Docket Item #9
BAR CASE #2006-0128

BAR Meeting
September 6, 2006

ISSUE: Rear addition and alterations

LOCATION: 509 Cameron Street

Figure 1 - Proposed rear

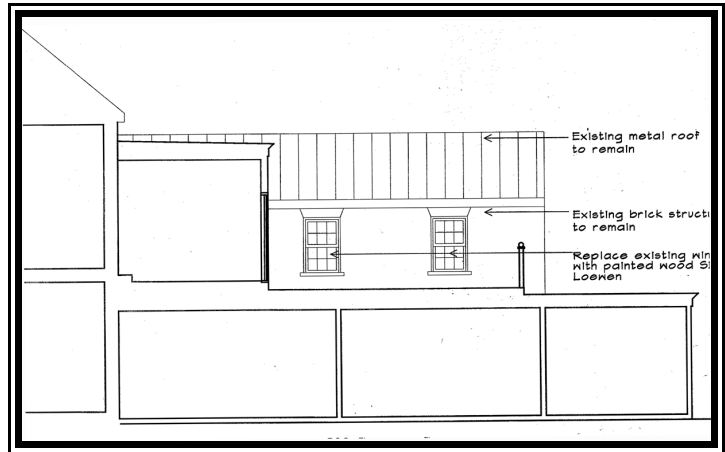
The proposed addition will be on the north side of the historic main block and the east side of the rear flounder. The addition to the main historic block is two stories in height and measures approximately 15' in length by 11' in width and then steps down to one story in height and is an additional 25'6" in length. The one story section will have a wood railing at the north end. The walls of the new addition will be sheathed in HardiPlank. The second story of the new addition will have one six-over-six window and a single multi-light door on the first level. All of the windows and doors on the addition are proposed to be wood with simulated divided lights clad and all trimwork is proposed to be of Fypon.

The western window on the rear of the flounder will become a new multi-light wood door and the eastern window will be replaced with a new wood window with simulated divided lights.

The existing four windows on the second level of the flounder ell will be eliminated and replaced with two non-symmetrical wood windows with simulated divided lights.

While the addition clearly changes the overall configuration of the rear of the house, Staff is willing to support the proposal for a number of reasons. First, the rear of the house is only minimally visible across the public surface parking lot from North St. Asaph Street and the public perception of the house from the street remains unchanged. Second, the materials proposed for the addition are clearly different than those of the historic house and create a clear differentiation between and old and the new. And third, the Board approved a rear addition to the early 19th century rear flounder at the residence adjacent to the west at 511 Cameron Street earlier this year (BAR Case #2006-0012, 2/15/06) which clearly changed the historic configuration creating, in the view of staff, the precedent for a similar type addition at this house.

2. The applicant must not allow metal detection to be conducted on the property, unless authorized by Alexandria Archaeology;
3. The above statements must appear in the General Notes of all site plans and on all site plan sheets that involve demolition or ground disturbance (including sheeting and shoring and grading) so that on-site contractors are aware of the requirements; and
4. Retention of the existing fenestration on the east wall of the second level of the existing ell.
